Access Compliance Report

Public Rights-of-Way

(Curb Ramps)

Intersection ID: 15291	Main Street: OLD_MEADOW_RD	Cross Street: SPRINGBEAUTY_DR	Location: SE
ADA ID: E4E61F1EAE3E	Ramp Type: PerpDiag	Initial Pass/Fail: Fail	Overall Compliance: No
Severity Score: 22.5			
Codes/Mitigation Info/Possible Solution		Field Measurements/Component Compliance

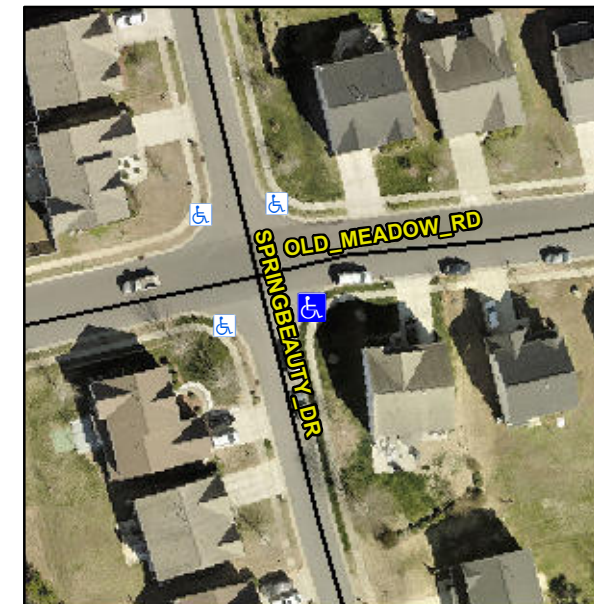
Not Found, R304.5.1, R304.2.2, R304.5.3

Compliance	Description	Data	Compliance	Description	Data
N/A	Ramp Length (in)	46.0	No	Ramp Slope (%)	9.1
No	Ramp Width (in)	44.0	No	Ramp XSlope (%)	2.7
N/A	Flare Type LT	N/A	N/A	Flare Type RT	N/A
N/A	Flare Slope LT (%)	N/A	N/A	Flare Slope RT (%)	N/A
N/A	Flare Traversable LT?	N/A	N/A	Flare Traversable RT?	N/A
N/A	Landing Length (in)	N/A	N/A	DWS Provided?	N/A
N/A	Landing Width (in)	N/A	N/A	DWS Contrast?	N/A
N/A	Landing Slope (%)	N/A	N/A	DWS Length (in)	N/A
N/A	Landing X Slope (%)	N/A	N/A	DWS Full Width?	N/A
N/A	Landing Curb? (Y/N)	N/A	N/A	DWS Offset (in)	N/A
N/A	Shared Landing?	N/A			
N/A	Gutter Ponding?	N/A	N/A	Gutter Slope (%)	N/A
N/A	Gutter Lip Ht (in)	N/A	N/A	Gutter X Slope (%)	N/A
N/A	Painted X Walk1?	No	N/A	Painted X Walk2?	No
	X Walk 1 Direction	To N		X Walk 2 Direction	To W
N/A	X Walk 1 Width (in)	N/A	N/A	X Walk 2 Width (in)	N/A
	X Walk 1 Slope (%)	3.4		X Walk 2 Slope (%)	3.9
	X Walk 1 X Slope (%)	4.0		X Walk 2 X Slope (%)	2.6

Remove & Replace Curb Ramp With Two New Directional Ramps or Equivalent.
